CAIRNGORMS NATIONAL PARK AUTHORITY

Dell 2 Wind Farm – Consultation from Scottish Government Energy Consents and Deployment Unit

REFERENCE: 2023/0068/PAC (ECU00003440)

RECOMMENDATION: No Objection

Figure 4.4a: Cumulative Site Plan (45km)

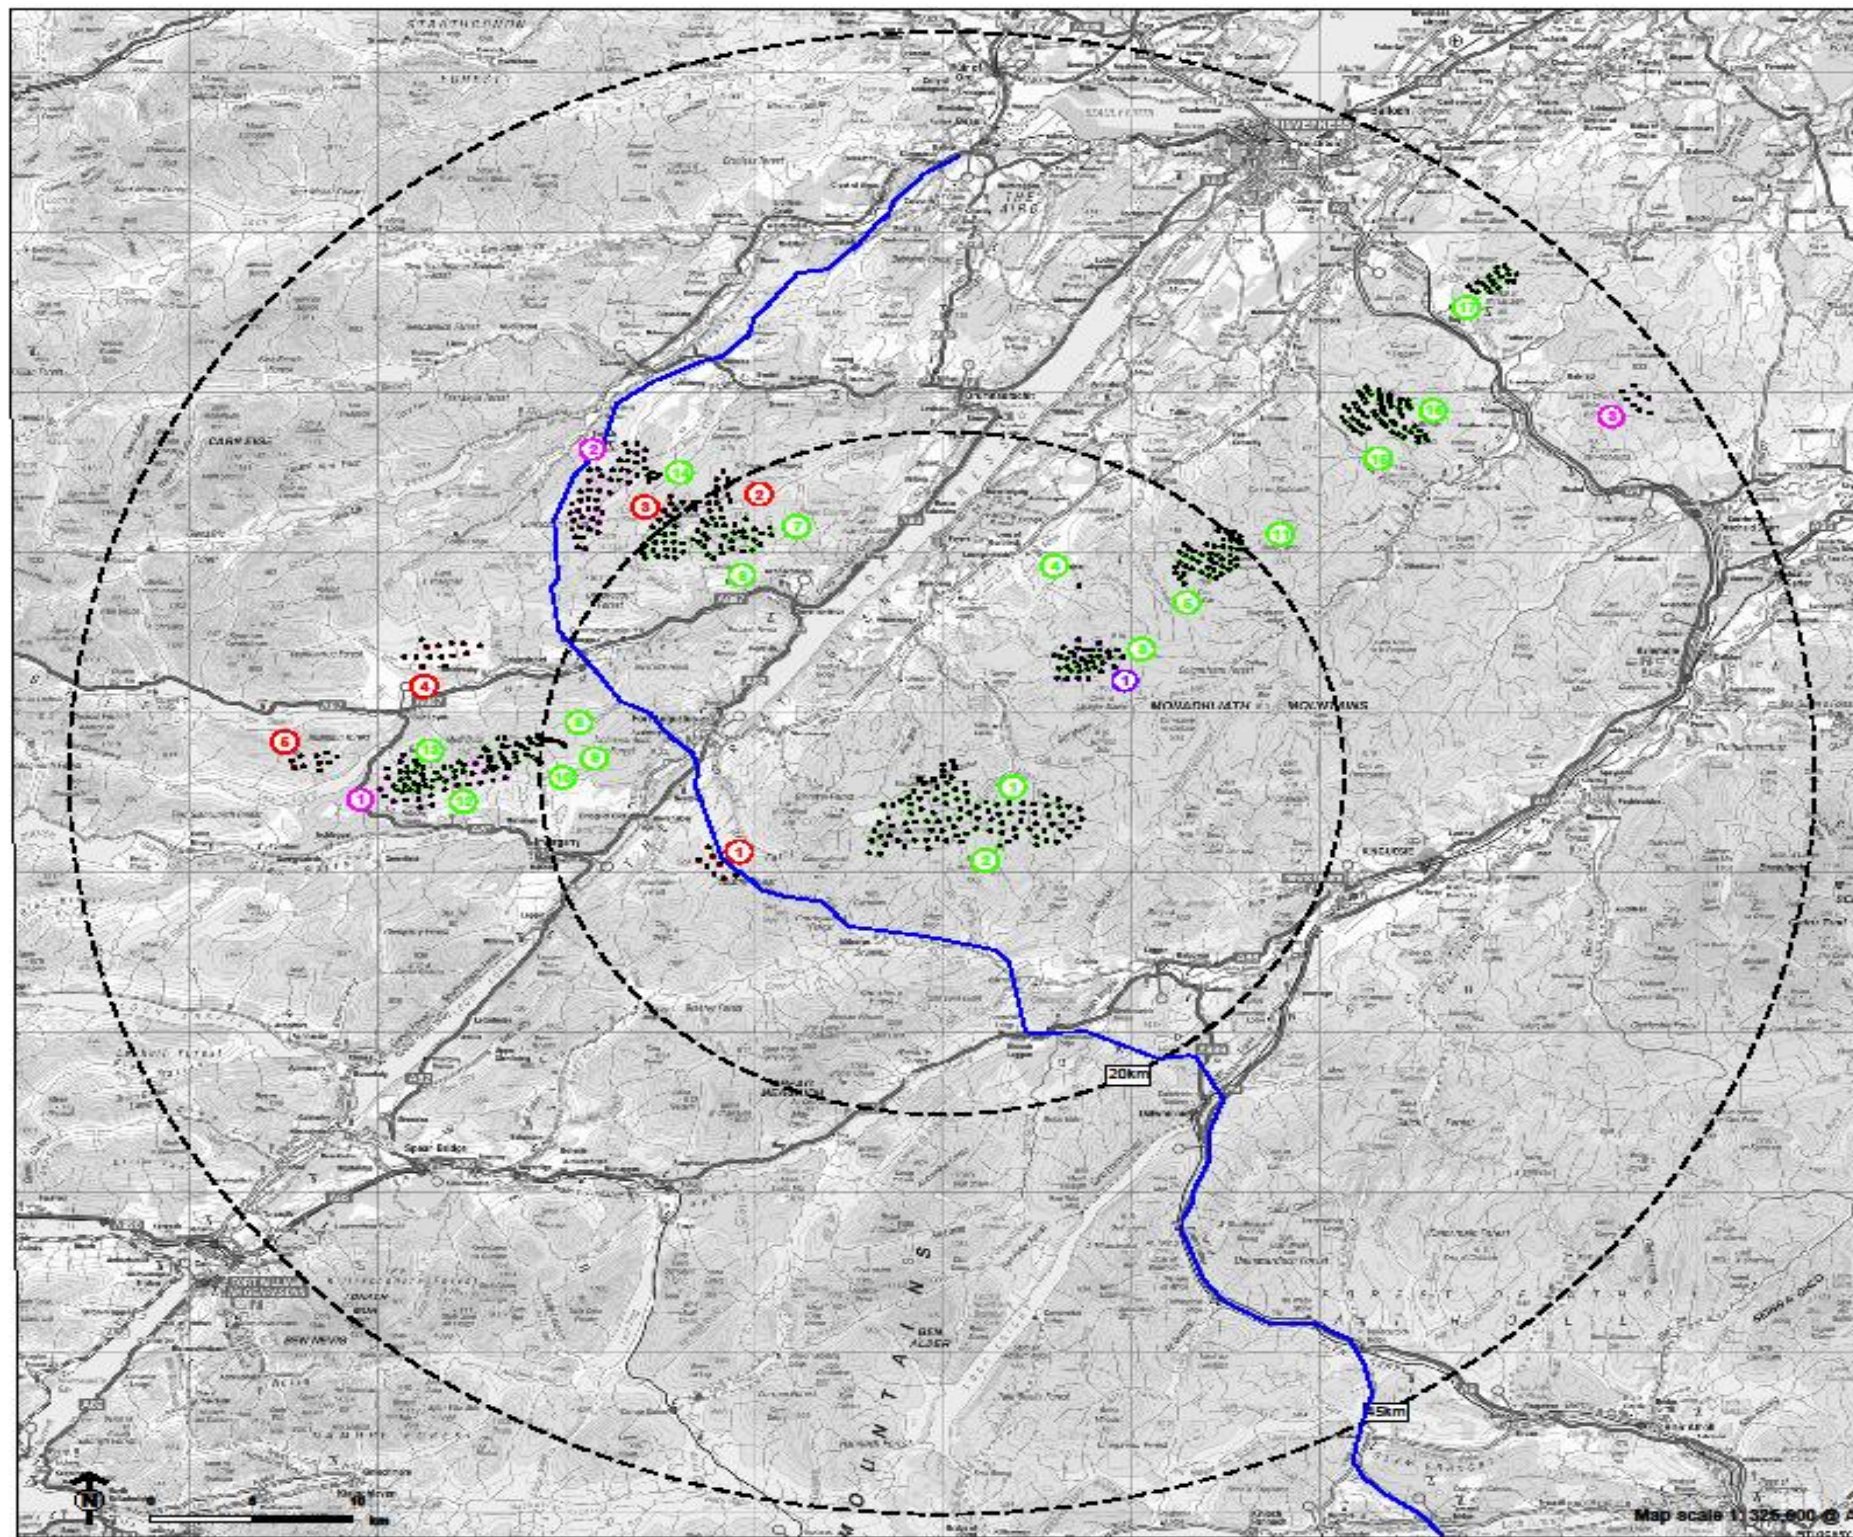
4. The Site (wind farm and site access) is located approximately 11km east of Fort Augustus, on the western edge of the Monadhliath Mountains (indicated on the EIA cumulative wind farm Figure 4.4a above). As such the proposal is wholly located within the administrative boundary of The Highland Council and outside the National Park.

6. In terms of consented but not yet operational development, Cloiche Wind Farm (37 turbines at 149.9m blade tip height) is located approximately 2.6km to the south-west of Dell 2, and an extension to Corriegarth for 16 turbines (149.9m blade tip height) is currently at appeal and sits approximately 7.3km to the north-east of the site. This cumulative relationship of existing, consented and proposed wind farms to Dell 2 are illustrated on the applicants EIA Report Figure 4.4a above.

28. There are a number of existing and consented wind farms in the area surrounding the proposed wind farm, as shown on page 2 of this report. Adding the proposed Dell 2 wind farm to the baseline would not significantly add to the existing level of effects, either alone or in combination with other existing or consented wind farms. This aspect is well illustrated by the cumulative ZTV in Appendix 2 and presented in the photomontage from Viewpoint 8.
